March 27, 2006  
LIC-06-0023

**SUBJECT: Response to Requests for Additional Information and Revision of Fort Calhoun Station Unit No. 1 License Amendment Request, "Criticality Control During Spent Fuel Cask Loading in the Spent Fuel Pool"**

**Attachment 1**  
**Omaha Public Power District (OPPD) Response to NRC's Request for Additional**  
**Information (RAI) on Fort Calhoun Station, Unit No. 1**  
**License Amendment Request (LAR)**  
**"Criticality Control During Spent Fuel Cask Loading in the Spent Fuel Pool"**

**Figure 6-1**

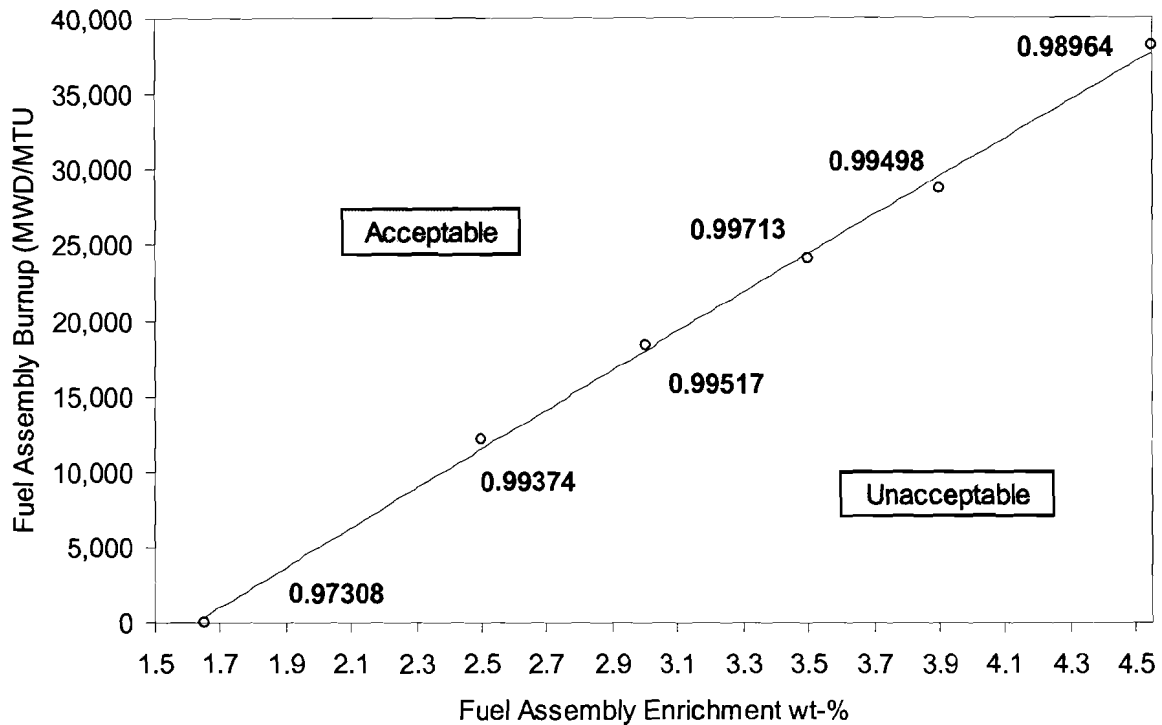
*Clarify the discrepancy between Summary bullet 1 and page 21 of 36.*

The correction above warranted further review of the report and a typographical error was found in the Table 6-1. Namely, the KENO  $k_{eff}+2\sigma$  results for the 4.55 w/o U-235 case contained a typographical error which is corrected below. The correction is also applied to Figure 6-1.

The criticality analysis, Page 21 of 36, enclosed with LIC-05-0119 provided the cask assembly for a case with 500 ppm of soluble boron. The  $k_{eff}$  value listed did not include the 0.013  $\Delta k_{eff}$ . This inadvertent omission is corrected below and the results continue to demonstrate the cask assembly  $k_{eff}$  is below 0.95.

The first bullet of the summary has been changed to reflect the correction discussed above and is now consistent Table 6-1:

- The most reactive DSC cask configuration (normal case) has a  $k_{eff} < 1$  (i.e., 0.99713) with unborated water and a  $k_{eff} < 0.95$  (i.e., 0.92073) when flooded with borated water at a concentration of 500 ppm. Both cases apply burnup credit.

Enclosure 1 of this letter contains the revised Calculation Summary “NUHOMS-32PT 50.68 Criticality Analysis for Fort Calhoun,” incorporating corrections as noted above.

Figure 6-2  
DSC and Transfer Cask Position in the SFP Cavity<sup>[8,10]</sup>

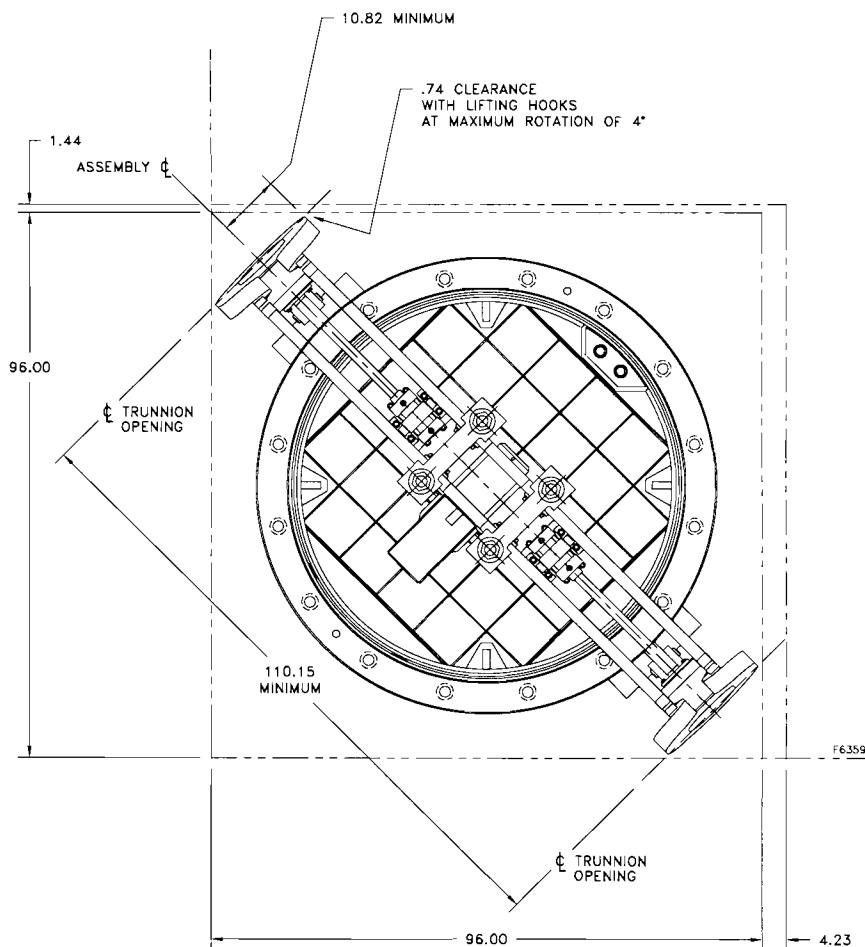
*The DSC position in the spent fuel cavity is described as being 3 inches from the spent fuel racks. Later in the application, the location is described as being 3 centimeters. State the correct spacing between the fuel racks and the cask and whether the model was conservative in accounting for neutron coupling in the criticality analysis.*

In the first paragraph of the License Amendment Request, Reference 3, section 4.1.3.6, Dry Shielded Canister, DSC, Position in the Spent Fuel Pool, SFP, Cavity, (page 12 of Attachment 1 to Reference 2) the unit of "inches" was incorrectly used. The fourth sentence should read, "In this orientation, the closest the transfer cask can approach the spent fuel racks is approximately three centimeters." The dimension of three centimeters is consistent with the dimension provided in section 6.5, DSC Position in the SFP Cavity, on page 23 of 36 of Enclosure 1 of Reference 2 and is the more conservative distance, i.e., the shortest distance, for neutron coupling.
